Work Order ID 75210

Item Name: Crosstube Turning Detail

DRAWING NO. D212-664-147	TITLE CROSSTUBE ASS'Y (205 LOW FWD)	REV. B	DART AEROSPACE LTD ENGINEERING ORDER		D.E.O. NO. D212-664-147-B-1	SHEET NO. SHEET 1 OF 1	SCALE NTS
DRAWN <i>qp</i>	CHECKED <i>ASS</i>	MFG. APPR. <i>185</i>	APPROVED <i>MP</i>		DE APPR. <i>MP</i>		
DATE 11.07.15	DATE 11.07.20	DATE 11.07.21	DATE 11/07/21		DATE 11.07.21

REPLACE MAGNOBOND WITH PROSEAL.

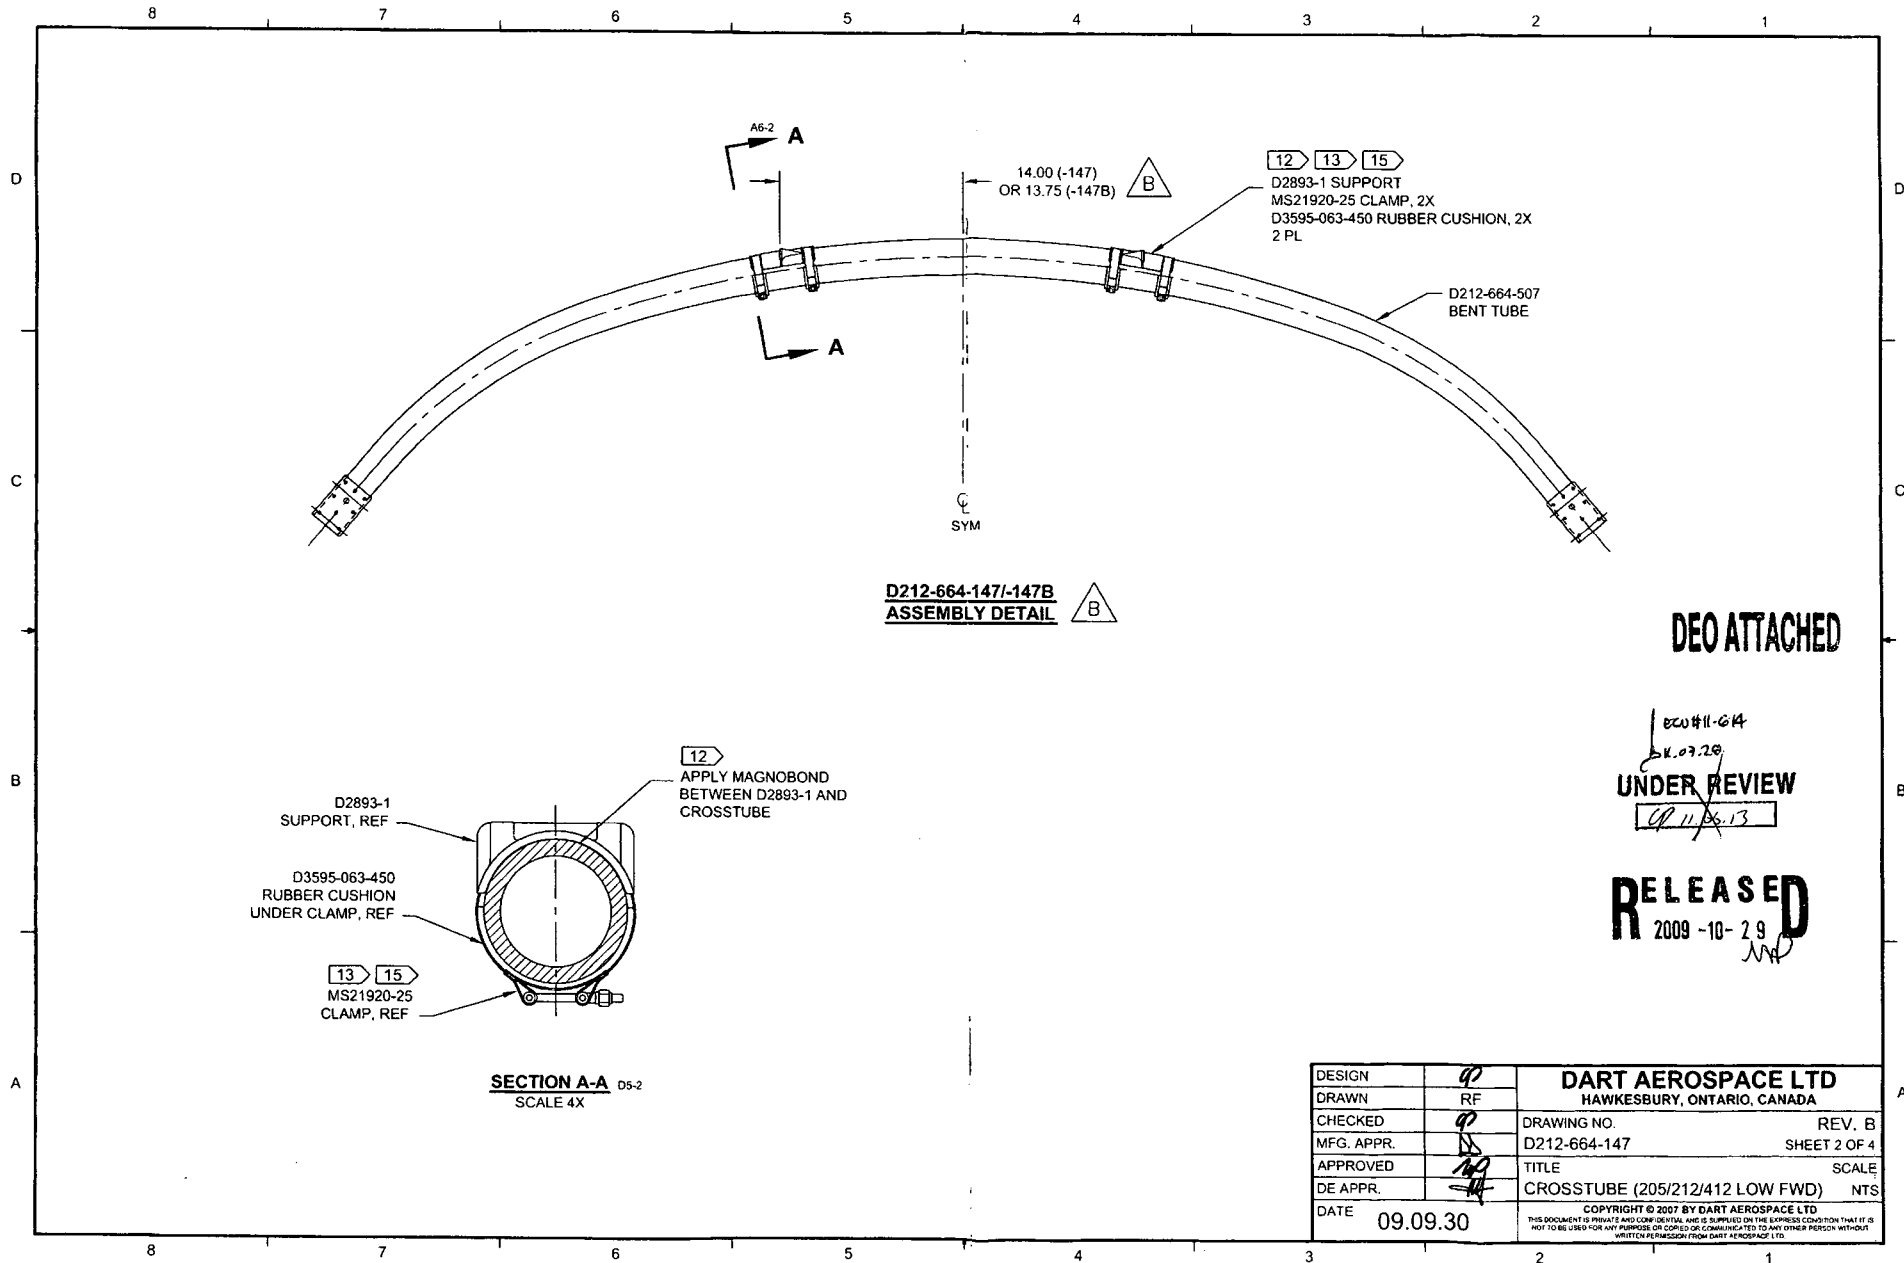
NOTE 12 & 15, SHEET 1 IS AMENDED AS FOLLOWS:

Item	Qty -147	Qty -147B	Part Number	Description
9	A/R	A/R	PROSEAL 890 B-2	SEALANT, AMS-S-8802 CLASS B-2

- 12) TO INSTALL D2893-1 SUPPORT: ABRASE MATING SURFACE OF SUPPORT AND CROSSTUBE WITH 180-GRIT SANDPAPER AND REMOVE RESIDUE WITH MEK (OR EQUIVALENT). APPLY A 0.04" TO 0.07" THICK LAYER OF PROSEAL 890 CLASS B-2 (OR AMS-S-8802 CLASS B-2) SEALANT TO MATING SURFACE OF SUPPORT.
- 15) TORQUE CLAMPS 80 TO 100 IN-LB. ENSURE AT LEAST 1.5 THREADS SHOWING IN SAFETY AND THAT NUT HAS NOT BOTTOMED-OUT AFTER TORQUING. **PRIOR TO PACKAGING, RE-CHECK TORQUE ON CLAMPS AFTER PROSEAL 890 SEALANT HAS CURED FOR 72 HOURS.**

D212-664-147TRN
TURNING DETAIL

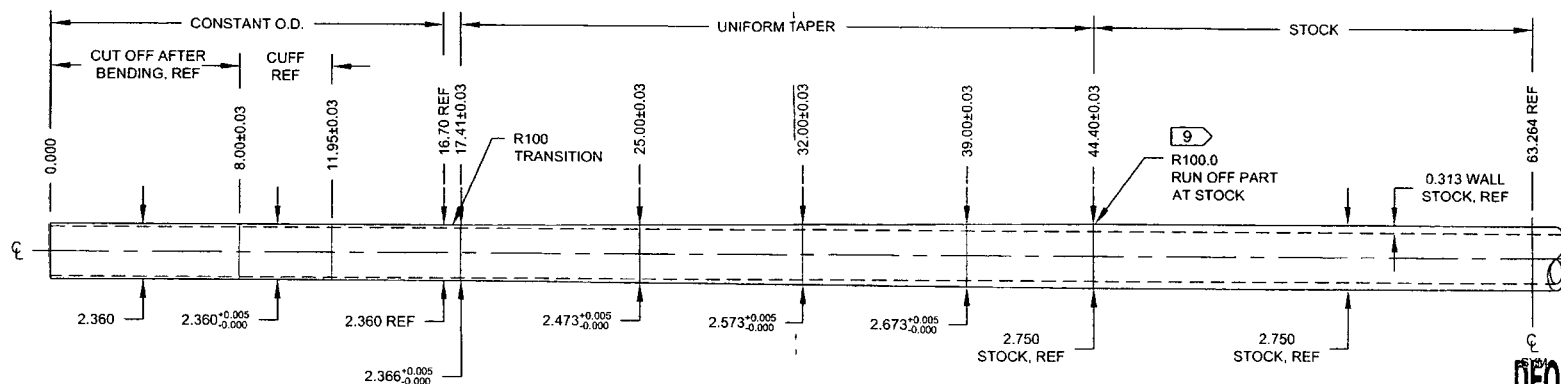
W/O: 75210		WORK ORDER CHANGES					
DATE	STEP	PROCEDURE CHANGE	By	Date	Qty	Approval Chief Eng / Prod Mgr	Approval QC Inspector
11.10.26	100	Acceptable to MANUFACTURE XTUBE USING D6005-128 EXTRUSION WITH ID = 2.000". ACCEPTABLE BASED ON TESTING COMPLETED PER TR-D412-664-16 REV.3	CP	11.10.26	1	 11.10.26
